Access Compliance Report

Public Rights-of-Way

(Curb Ramps)

Intersection ID: 12539	Main Street: KIMMERLY_GLEN_LN	Cross Street: KIMMERLY_CREEK_DR	Location: NE
ADA ID: 0A3D3147F1F1	Ramp Type: BlendTrans1	Initial Pass/Fail: Fail	Overall Compliance: No
		Severity Score: 12.5

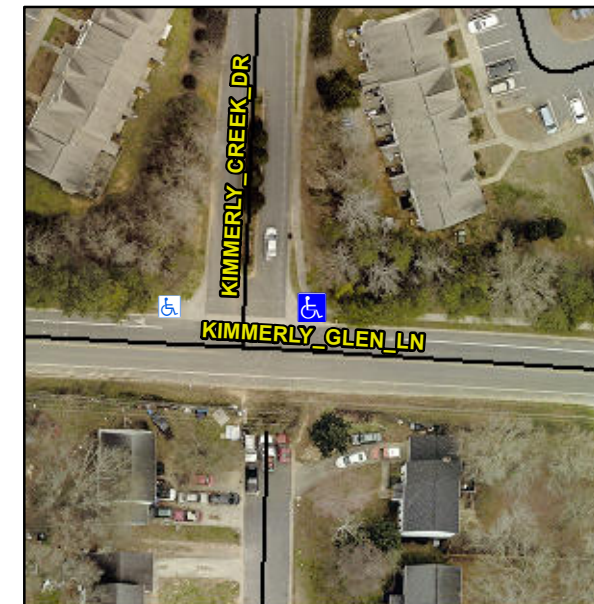
NO LNDG

Not Found, R304.5.3

Compliance	Description	Data	Compliance	Description	Data
N/A	Ramp Length (in)	97.0	Yes	BlendTrans Slope (%)	2.1
Yes	Ramp Width (in)	50.0	No	BlendTrans XSlope (%)	5.5
N/A	Flare Type LT	N/A	N/A	Flare Type RT	N/A
N/A	Flare Slope LT (%)	N/A	N/A	Flare Slope RT (%)	N/A
N/A	Flare Traversable LT?	N/A	N/A	Flare Traversable RT?	N/A
N/A	Landing Length (in)	N/A	N/A	DWS Provided?	N/A
N/A	Landing Width (in)	N/A	N/A	DWS Contrast?	N/A
N/A	Landing Slope (%)	N/A	N/A	DWS Length (in)	N/A
N/A	Landing X Slope (%)	N/A	N/A	DWS Full Width?	N/A
N/A	Landing Curb? (Y/N)	N/A	N/A	DWS Offset (in)	N/A
N/A	Shared Landing?	N/A			
N/A	Gutter Ponding?	N/A	N/A	Gutter Slope (%)	N/A
N/A	Gutter Lip Ht (in)	N/A	N/A	Gutter X Slope (%)	N/A
N/A	Painted X Walk1?	No	N/A	Painted X Walk2?	No
	X Walk 1 Direction	To W		X Walk 2 Direction	To S
	X Walk 1 Width (in)	N/A		X Walk 2 Width (in)	N/A
	X Walk 1 Slope (%)	2.3		X Walk 2 Slope (%)	1.6
	X Walk 1 X Slope (%)	0.6		X Walk 2 X Slope (%)	2.5

N/A	Ramp inside XWalk1?	N/A	N/A	Ramp inside XWalk2?	N/A
	Road Slope (%)	1.8		Clear Space?	N/A
	Road X Slope (%)	0.8	N/A	Clear Space to XWalk (in)	N/A
N/A	Any Obstructions?	N/A	N/A	Storm Grate/Utility Hazard?	N/A
	Obstruction Type			Storm Grate/Utility Type	
		N/A			N/A
			Yes	Surface Condition? (G/P)	Good
			No	Curb Slope (%)	12.4

Remove & Replace Curb Ramp With Two New Directional Ramps or Equivalent.
